**Design Refinement/Environmental  
Impact Update Memo**

**Wis 29  
County VV Interchange  
Brown County, WI**

**Project I.D. 9200-10-00/71  
January 21, 2020**

**Exhibit 1**  
**Design Refinements Overview**

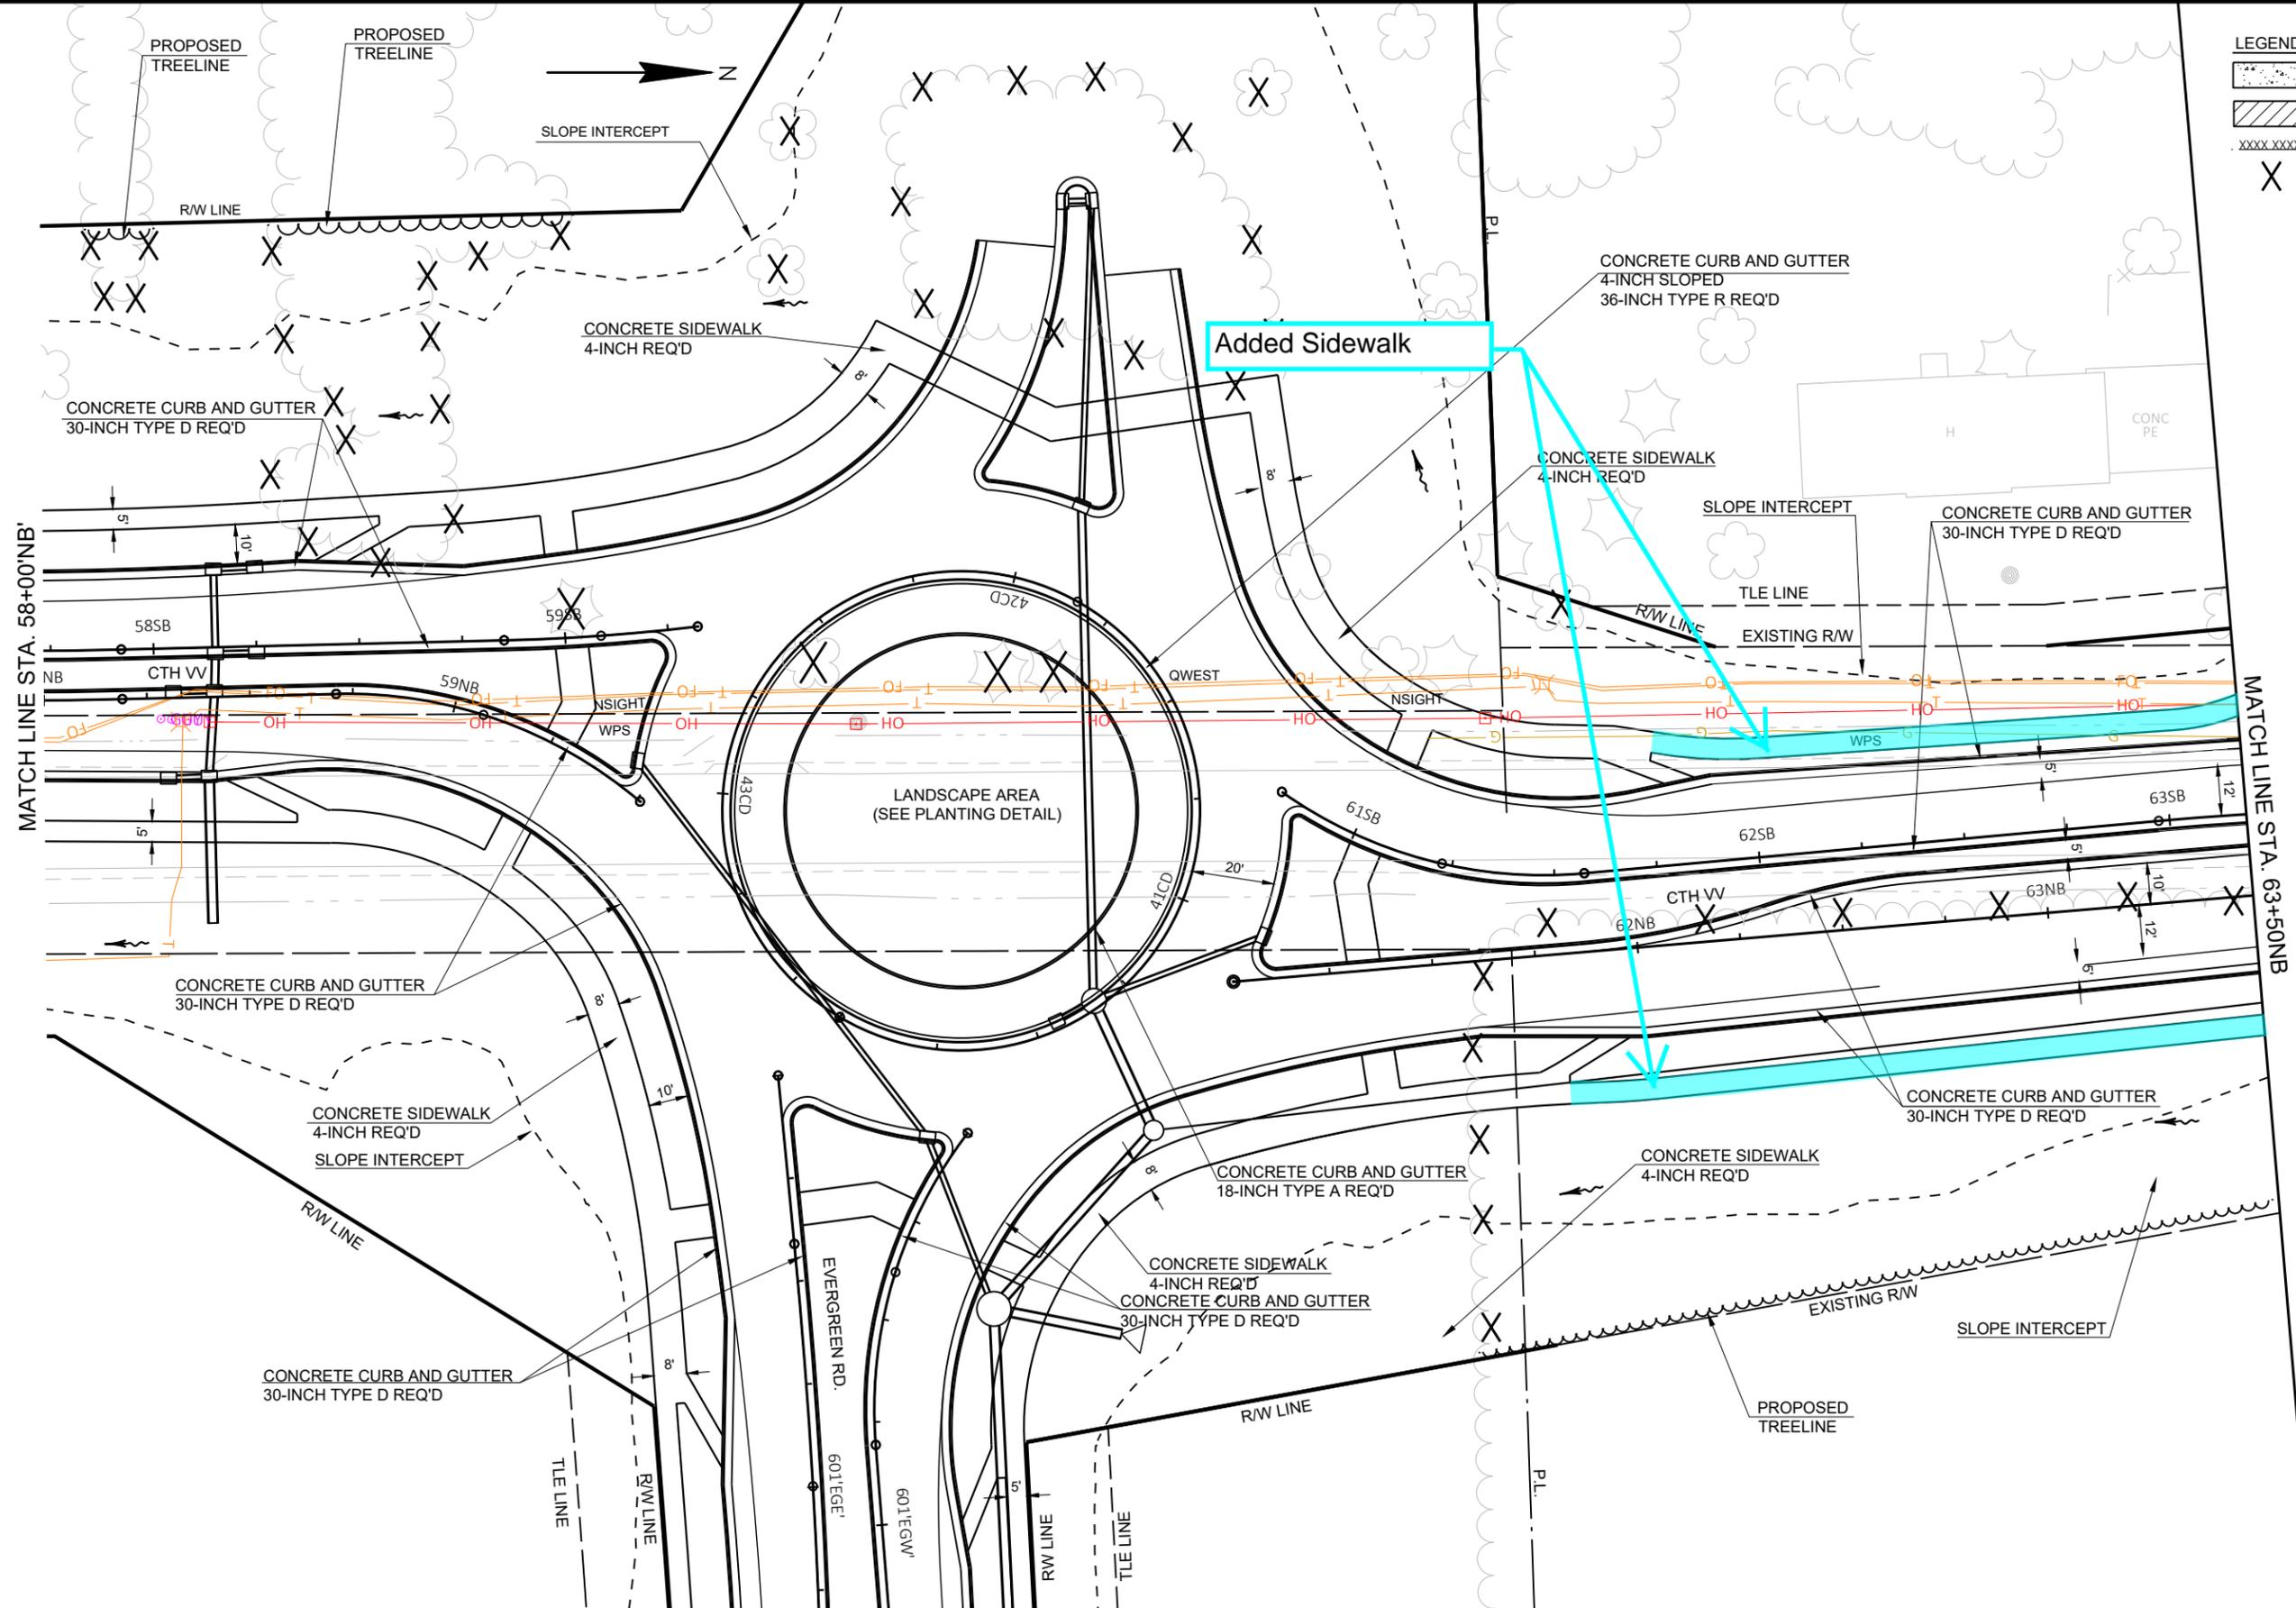
2. The location of the cul-de-sac on North Overland Road is proposed to be shifted slightly north. This would utilize WisDOT owned property and reduce the required fee title right of way acquisition for the project by approximately 0.2 acres.

3. Coordination with the Wisconsin Department of Natural Resources (DNR) on requirements for the storm water management allowed for a reduction of the footprint needed for the storm water pond adjacent to Evergreen Avenue. Through analysis of TSS reduction percentages for new roadway construction areas versus re-construction areas, the overall TSS reduction requirement for the project was reduced, and therefore the storm water pond size could also be reduced. This reduces the proposed need for approximately 1.54 acres of fee title right of way. There is also a proposed increase of 0.04 acres of TLE.

4. The location of the cul-de-sac for the connection roadway from Evergreen Ave. to existing Milltown Road is proposed to be shifted approximately 25 feet to the west to avoid the proposed need for 0.3 acres of fee title right of way from the Maplewood Meats property.

5. Due to a change in ownership of a property in the SW corner of the Overland Road and County VV intersection, proposed right of way acquisition of approximately 10 acres from the parcel is proposed to change from fee to Limited Highway Easement (LHE). While the manner of acquisition has changed, the acreage remains relatively consistent as stated in the ER. LHE acreage (previously fee) was reduced on this parcel by 0.20 acres due to item 2 above. Approximately an additional 0.2 acres of LHE was reduced on this parcel due to final design refinement of the roundabout on the

north end of Overland Road where it meets the existing County VV roadway. Additionally, approximately 0.2 acres of LHE was changed to TLE due to no longer needing a ditch and being able to maintain drainage via the storm sewer through sloping.

## **Exhibit 2**

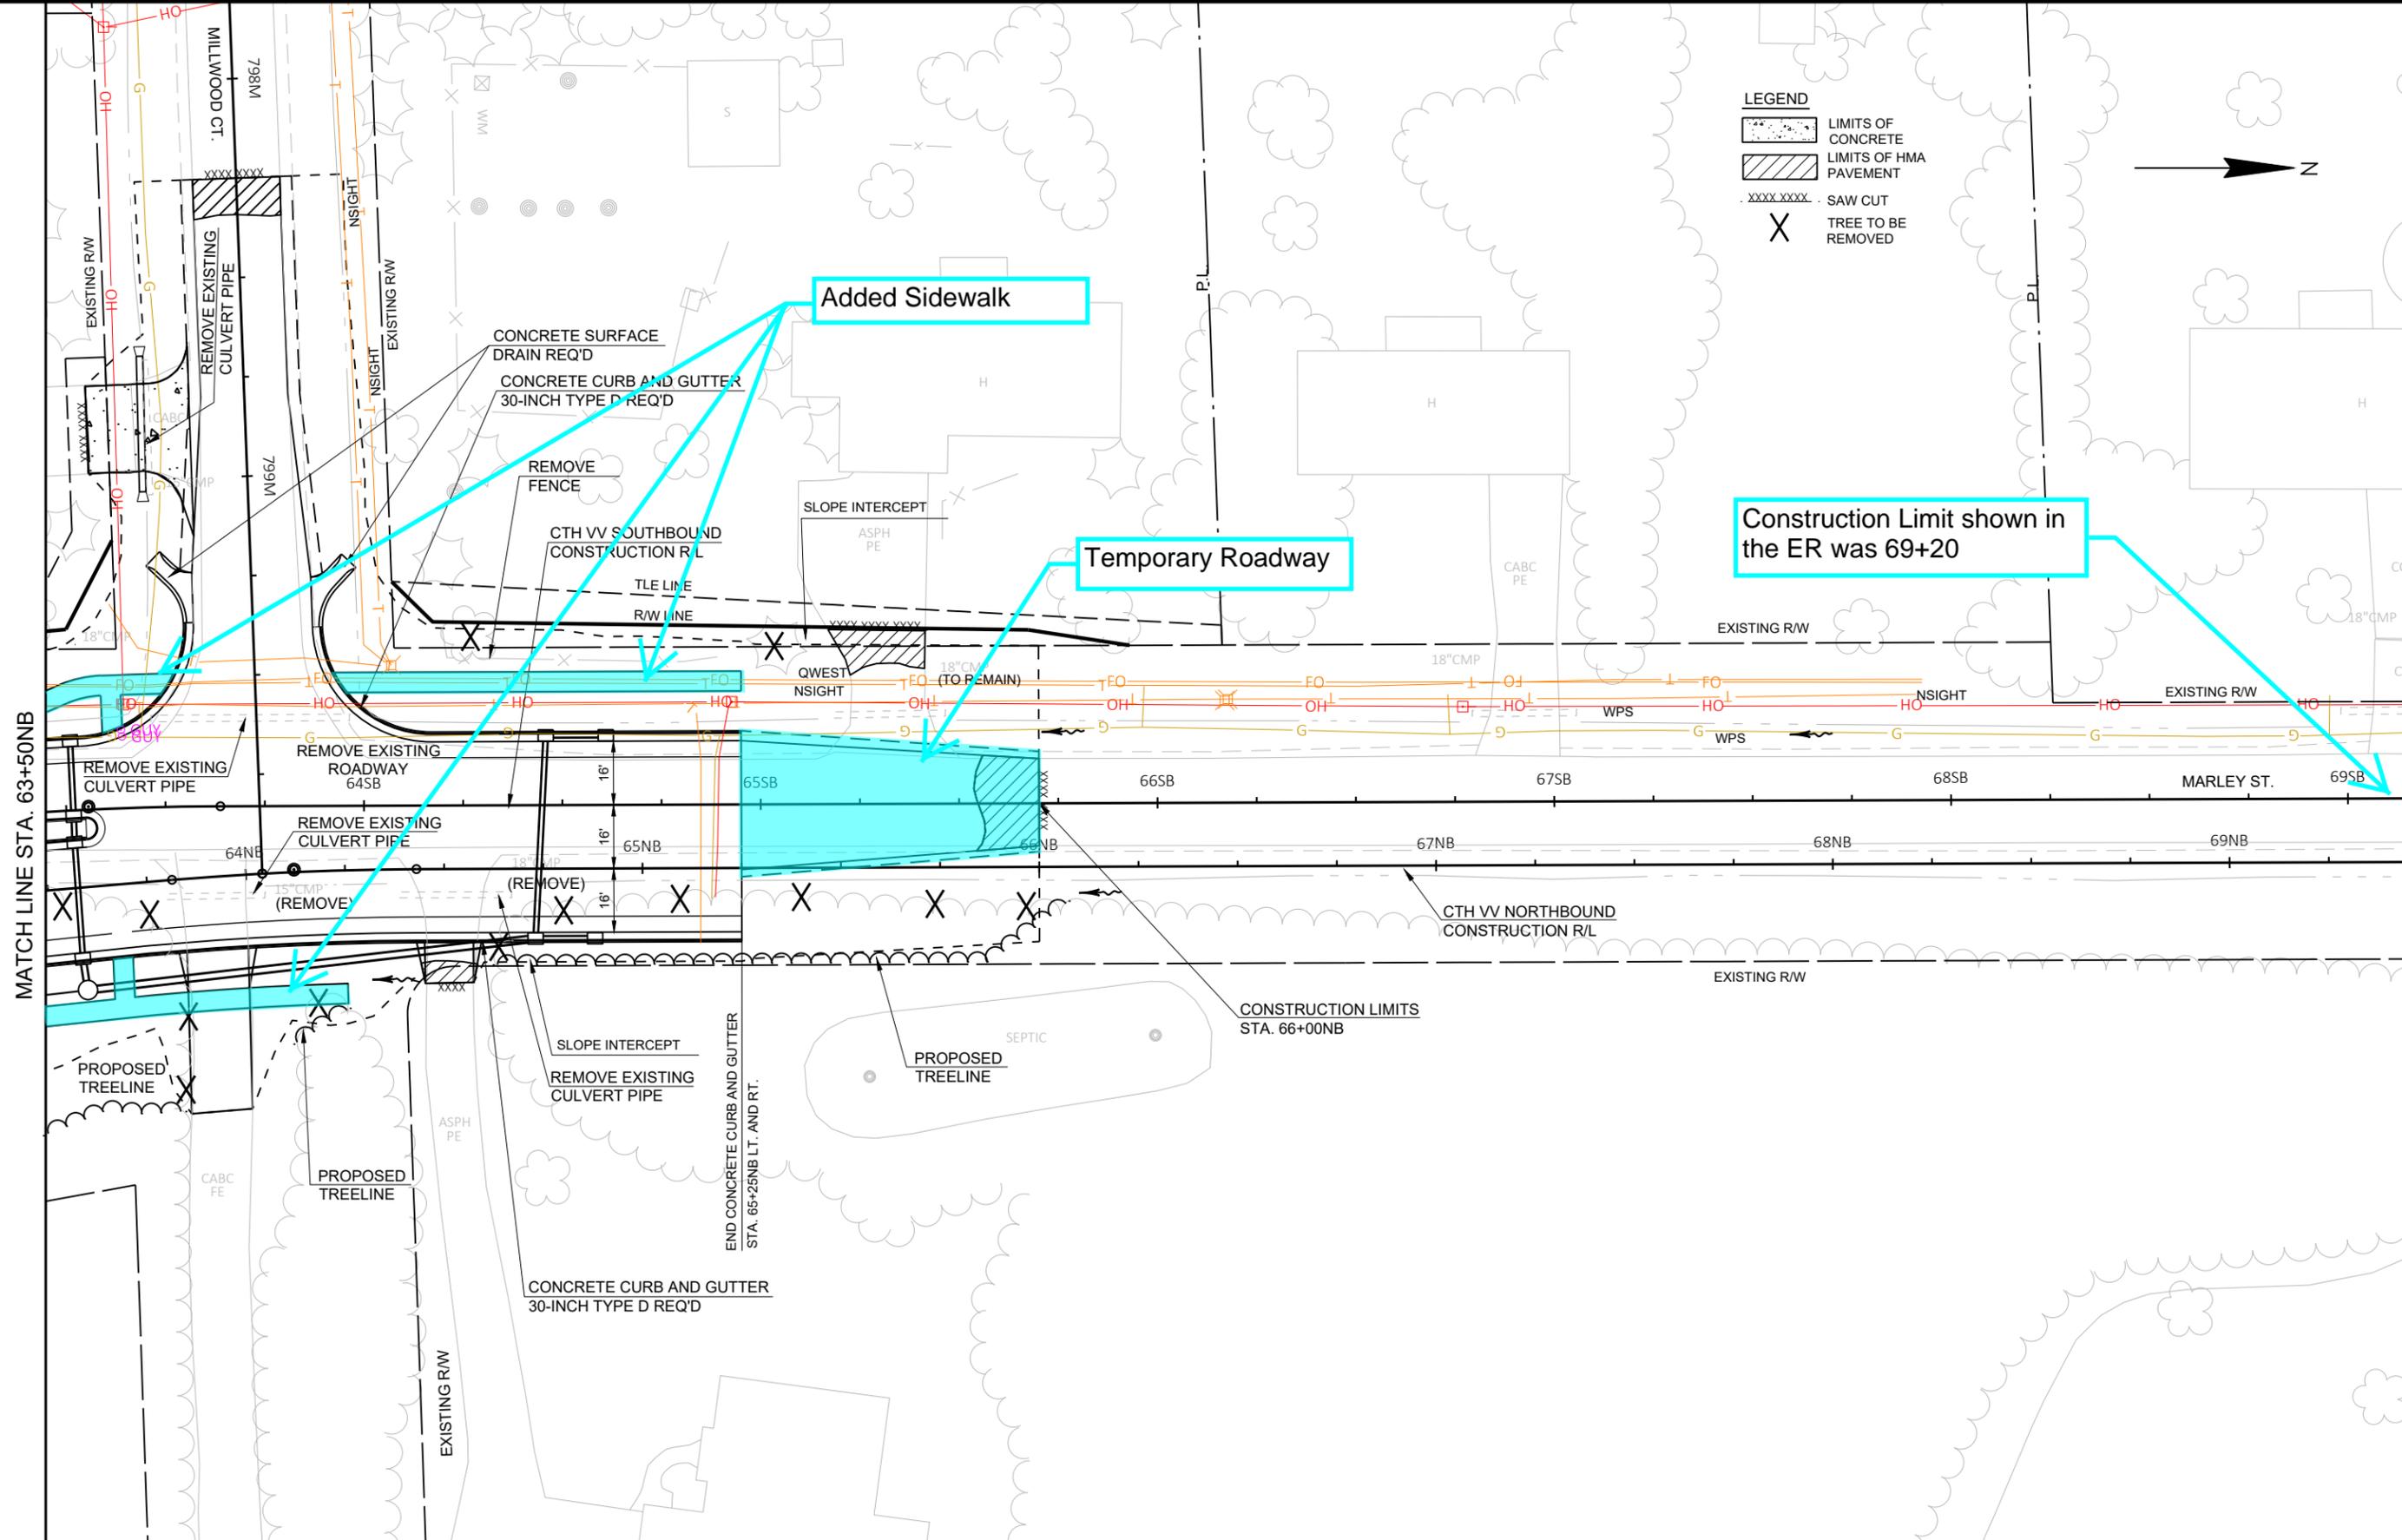
1. Brown County is proposing to reconstruct Marley Street on the north end of the WisDOT project in 2022 from Millwood Court to County C. This would shorten the north project limits of the WisDOT project by approximately 300 feet. The county also proposes to add sidewalk on both sides of the roadway north of Millwood Court. Therefore, sidewalk is proposed to be added by the WisDOT project to fill the gap between where the sidewalk would end north of the Evergreen up to Millwood Court. There is also a minor change to the proposed right of way acquisition. The amount of fee acquisition is proposed to be reduced by 0.08 Acres, while the amount of Temporary Limited Easement (TLE) is proposed to increase by 0.04 Acres. No other changes to the overall impacts listed in the ER are anticipated. A temporary roadway connection will be installed just north of Millwood Court as this portion of the interchange project will be constructed in 2021, but the Brown County project will not be constructed until 2022. See Exhibit 2.

Added Sidewalk

Temporary Roadway

Construction Limit shown in the ER was 69+20
